Agenda Item # 5 SUB-002910-2024

Chavers Oaks Subdivision

- Subdivision approval to create 45 legal lots of record from two (2) metes-and-bounds parcels.

APPLICATION NUMBER 5 DATE May 16, 2024

DETAIL SITE PLAN

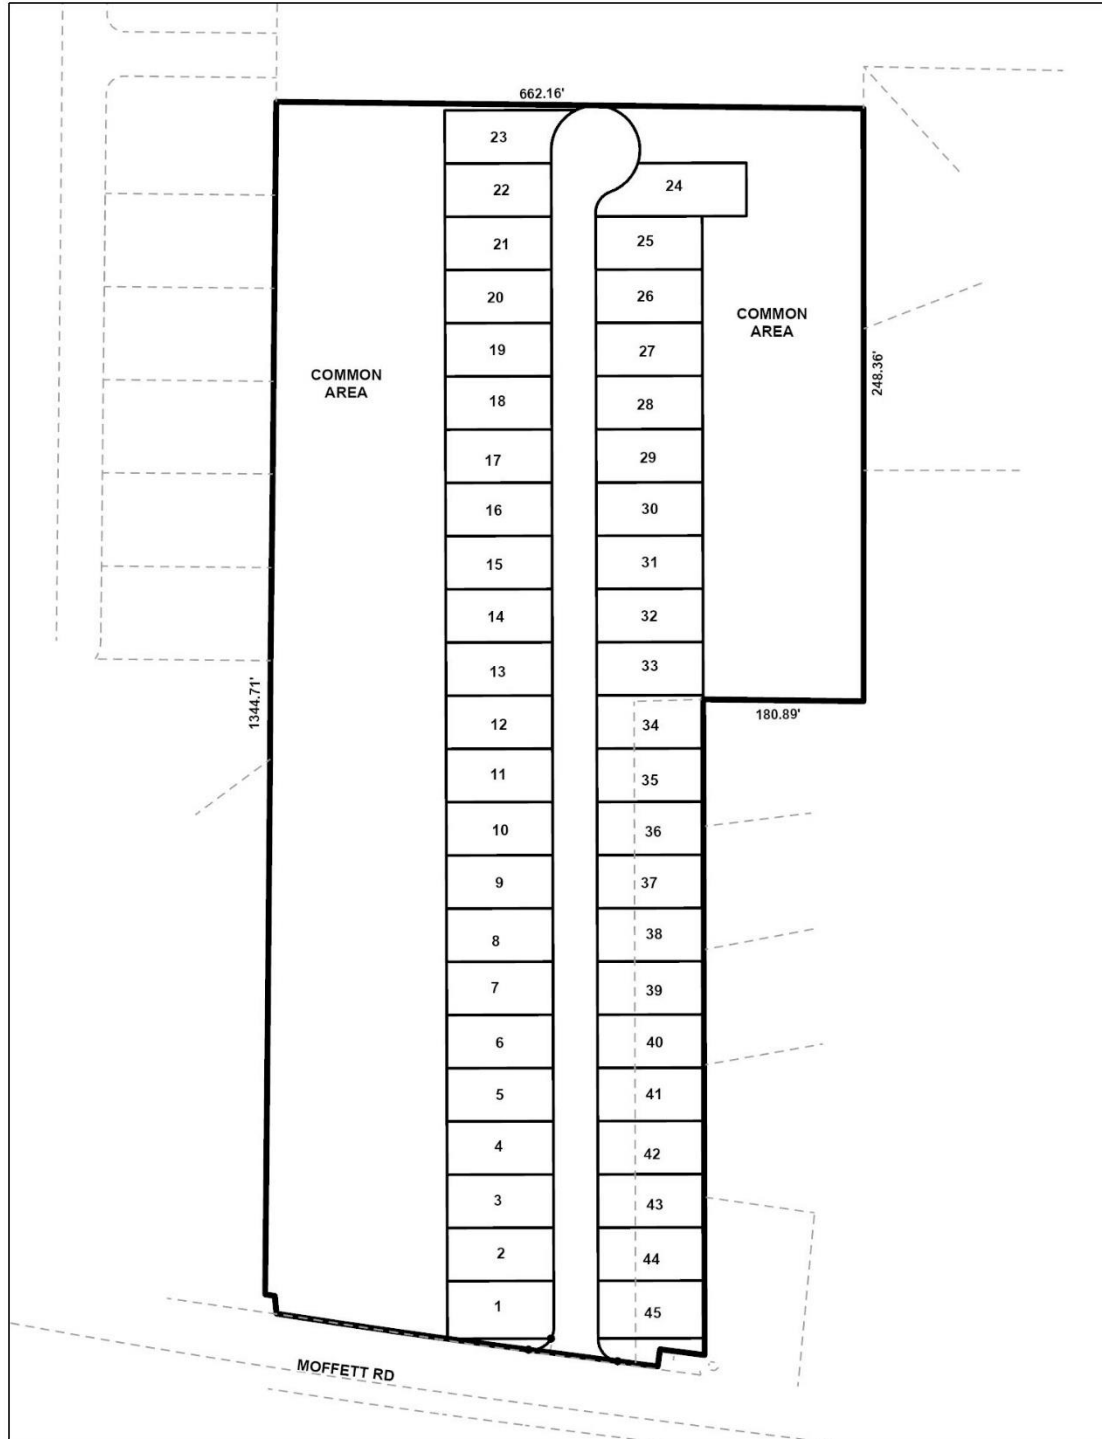
Access to the proposed subdivision is from Moffett Road, an ALDOT-maintained, Principal Arterial road requiring a 100-foot right-of-way at this location. No right-of-way is depicted on the preliminary plat; therefore, revision of the plat to illustrate dedication sufficient to provide 50 feet from the centerline of Moffett Road should be required, if approved. The right-of-way should also be labeled on the revised plat, if approved.

Moffett Road is not labeled on the preliminary plat. If approved, Moffett Road should be labeled on the Final Plat.

A turnaround is illustrated where Chavers Oaks Drive is proposed to end, in compliance with Section 6.B.3. of the Subdivision Regulations, but its diameter is not provided. For a closed-end street the right-of-way diameter is determined by the City Engineer and must comply with the most recently adopted International Fire Code (IFC). If approved, the plat should be revised to depict the right-of-way diameter of the turnaround, as approved by the Traffic Engineer, City Engineer, and the Fire Department to comply with the IFC.

Two (2) common areas are illustrated where the proposed Chavers Oaks Drive will intersect with Moffett Road, both of which are depicted with 25-foot corner radii, as required by Section 6.C.6. of the Subdivision Regulations. Each 25-foot corner radius should be retained on the Final Plat, if approved.

As proposed, each of the lots will meet the minimum size requirement for lots served by public water and sanitary sewer in the R-1 and LB-2 Suburban districts. The sizes of each lot are labeled in square feet on the preliminary plat, but not in acres, as required by Section 5.A.2.(e)(4) of the Subdivision Regulations. If approved, the size of each lot should be provided in both square feet and acres on the Final Plat; or provision of a table on the Final Plat with the same information may suffice.

It appears there are multiple common areas proposed, but they are not labeled as such and their sizes are not provided on the preliminary plat. If approved, revision of the plat to label each common area and to provide their sizes in both square feet and acres should be required, in compliance with Section 5.A.2.(f) of the Subdivision Regulations.

No front yard setbacks are illustrated on the preliminary plat. Section 6.C.8. of the Subdivision Regulations requires the minimum front yard setbacks of the underlying zoning district and sub-district to be illustrated along all streets adjoining the subdivision. As such, revision of the plat should be required to illustrate a 25-foot front yard setback along each existing and proposed street where each abutting lot and common area is at least 60 feet wide, in compliance with Section 6.C.8. of the Subdivision Regulations, and with Article 2, Sections 64-2-5.E. and 64-2-12.E. of the Unified Development Code.

1. Revision of the plat to label Moffett Road;
2. Revision of the plat to illustrate dedication sufficient to provide 50 feet from the centerline of Moffett Road;

3. Revision of the plat to depict an adequate turnaround diameter where the proposed street will terminate, with the design approved by the Traffic Engineer, City Engineer, and the Fire Department;

4. Retention of the 25-foot corner radii where the proposed Chavers Oaks Drive will intersect with Moffett Road, in compliance with Section 6.C.6. of the Subdivision Regulations;

5. Revision of the plat to provide the size of each lot and common area in both square feet and acres, in compliance with Sections 5.A.2.(e)(4) and 5.A.2.(f) of the Subdivision Regulations, or provision of a table on the Final Plat with the same information;

6. Revision of the plat to illustrate the 25-foot front yard setback along each existing and proposed street where each abutting lot and common area is at least 60-feet wide, in compliance with Section 6.C.8. of the Subdivision Regulations, and with Article 2, Sections 64-2-5.E. and 64-2-12.E. of the UDC;
